Access Compliance Report
Public Rights-of-Way
(Curb Ramps)

Intersection ID: 5075	Main Street: FERNMOSS_CT	Cross Street: HEDGECREST_PL	Location: SE
ADA ID: AF87E1B025AD	Ramp Type: Directional1	Initial Pass/Fail: Fail	Overall Compliance: No	Severity Score: 21.25

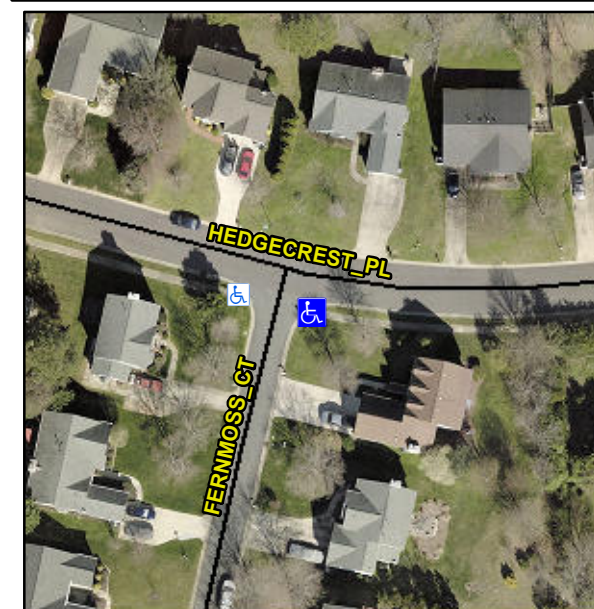
R304.5.1, R304.2.2

Compliance	Description	Data	Compliance	Description	Data
N/A	Ramp Length (in)	56.0	N/A	Grade Break?	N/A
No	Ramp Width (in)	43.5	N/A	Grade Break Slope (%)	0.0
No	Ramp Slope (%)	10.6	N/A	Grade Break XSlope (%)	0.0
Yes	Ramp XSlope (%)	1.5			
N/A	Flare Type LT	N/A	N/A	Flare Type RT	N/A
N/A	Flare Slope LT (%)	N/A	N/A	Flare Slope RT (%)	0.0
N/A	Flare Traversable LT?	N/A	N/A	Flare Traversable RT?	N/A
N/A	Landing Length (in)	0.0	N/A	DWS Provided?	N/A
N/A	Landing Width (in)	0.0	N/A	DWS Contrast?	N/A
N/A	Landing Slope (%)	0.0	N/A	DWS Length (in)	N/A
N/A	Landing X Slope (%)	0.0	N/A	DWS Full Width?	N/A
N/A	Landing Curb? (Y/N)	N/A	N/A	DWS Offset LT (in)	N/A
N/A	Shared Landing?	N/A	N/A	DWS Offset RT (in)	N/A
N/A	Gutter Ponding?	0.0	N/A	Gutter Slope (%)	N/A
N/A	Gutter Lip Ht (in)	0.0	N/A	Gutter X Slope (%)	N/A
N/A	Painted X Walk1?	No		Road Slope (%)	4.7
	X Walk 1 Direction	To W		Road X Slope (%)	5.9
	X Walk 1 Width (in)	N/A		Clear Space?	N/A

Remove & Replace Entire Ramp.
